## NEGOTIATED DECISION NOTICE APPROVAL

I wish to advise that 12 August 2024, a decision was made to issue a Negotiated Decision Notice to amend Condition 7 and delete Condition 20 under Section 76 (3) of the *Planning Act 2016*.

**Application number:** P06-23  
**Approval sought:** Material Change of Use  
**Nature of development proposed:** Extension to Existing Hotel and (Bottle) Shop  
**Description of the development proposed:** Internal Renovations to an Existing Hotel and a New Enclosed Bottle Shop and Drive-Thru

Street address: 55 Barkly Highway  
Real property description: Lot 1 on plan MPH7977  
Local government area: Mount Isa City

drawing title Proposed Site Plan

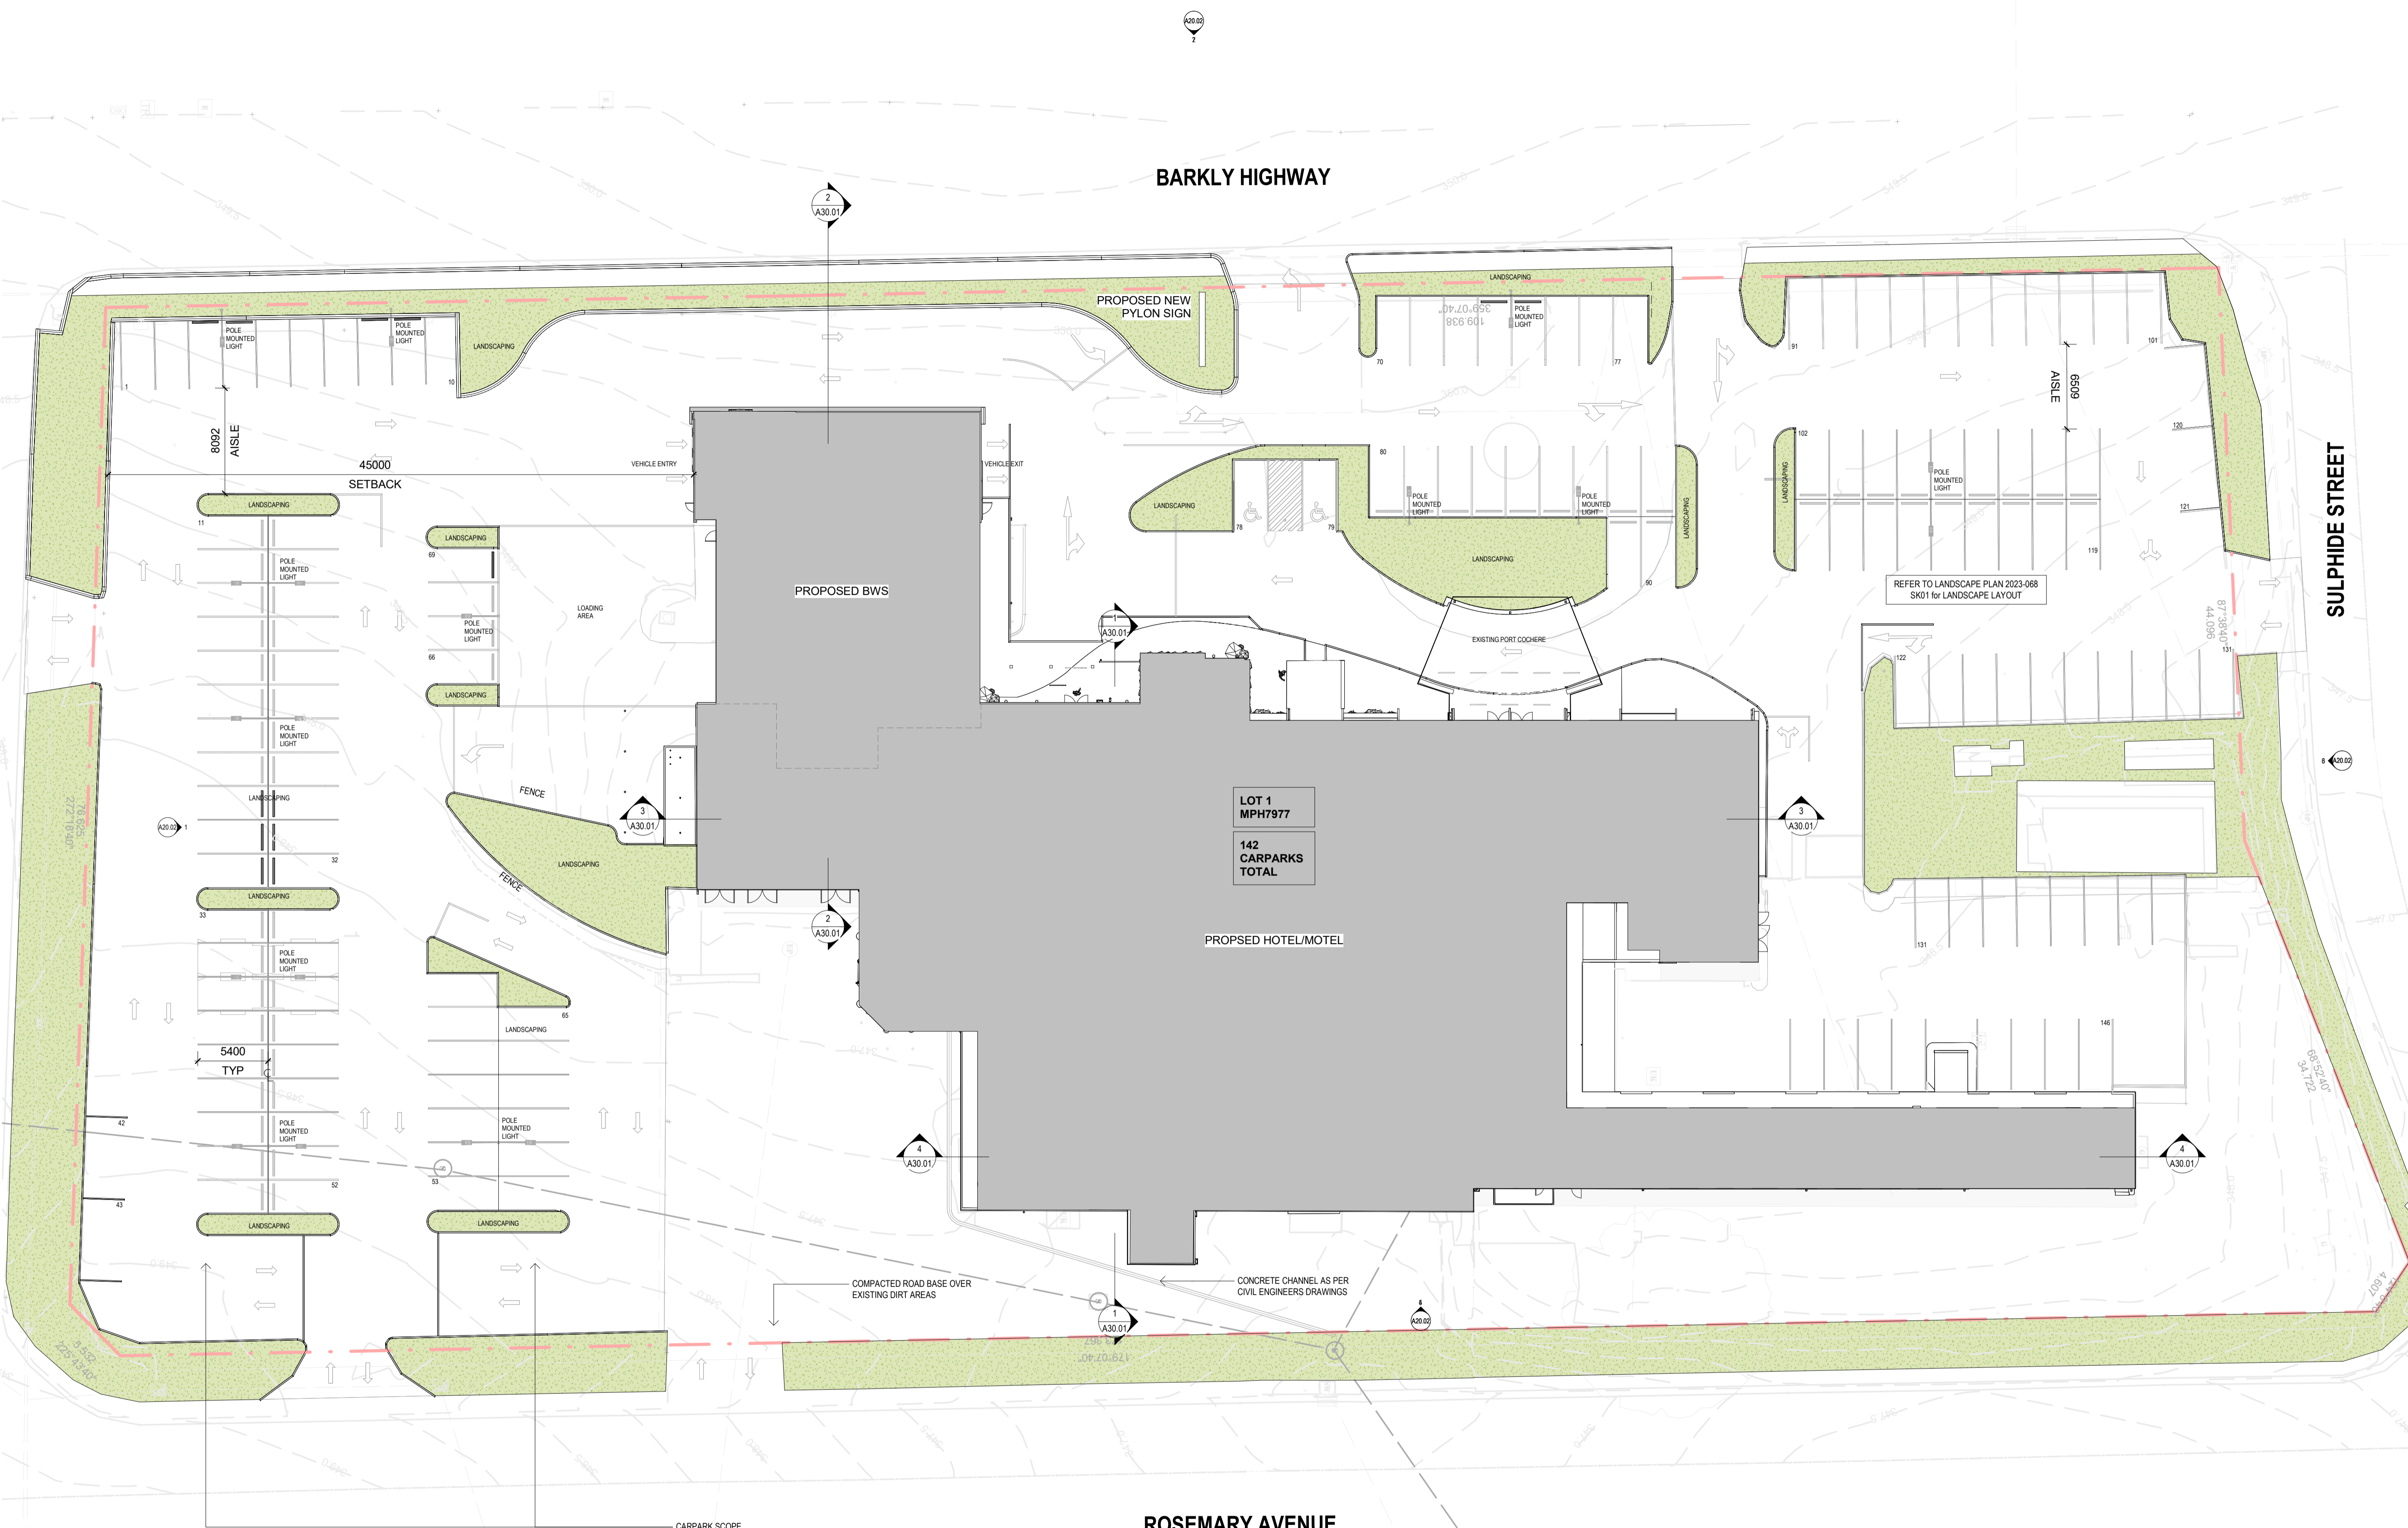
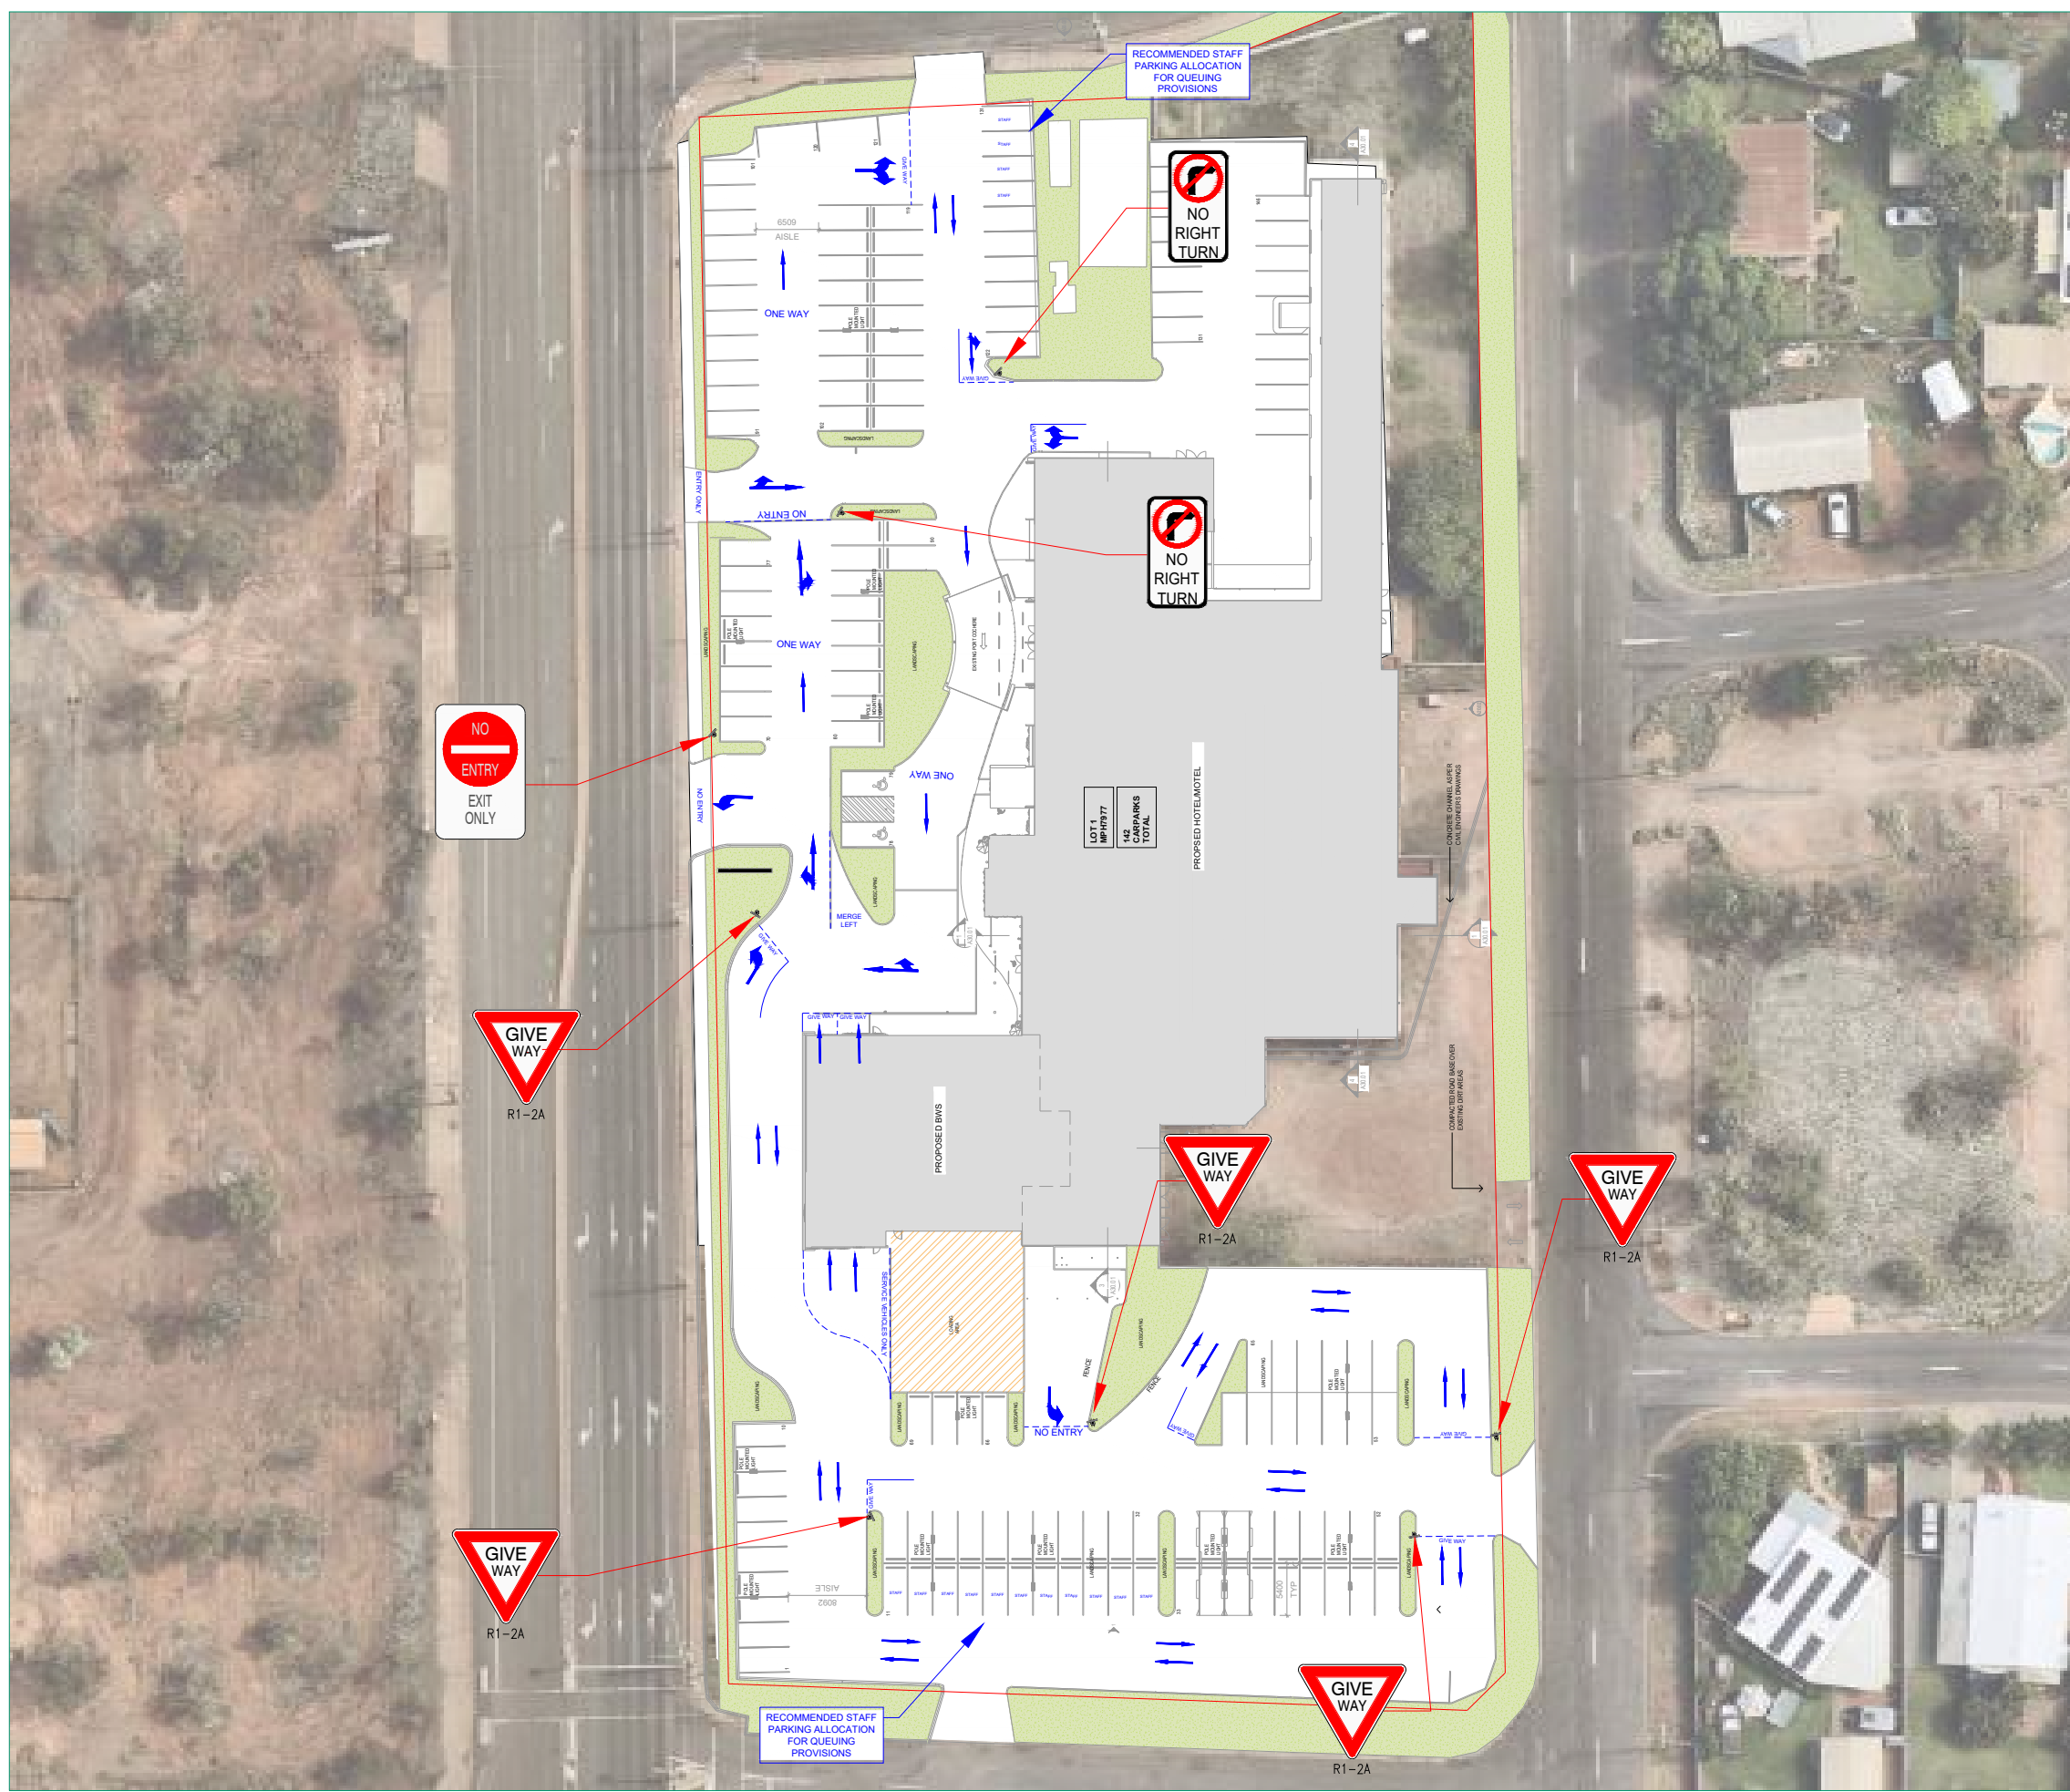
(A) Condition 7 of Council Decision Notice issued 24 June 2024 be amended as follows

7.	The 142 onsite carparking spaces as per plan, <i>Proposed Site Plan – Project No 2033 Dwg No. A00.05 Issue J Prepared by Cayas + Ward</i> , shall be provided and maintained <b>for the life of the development</b> ;	
----	---	--
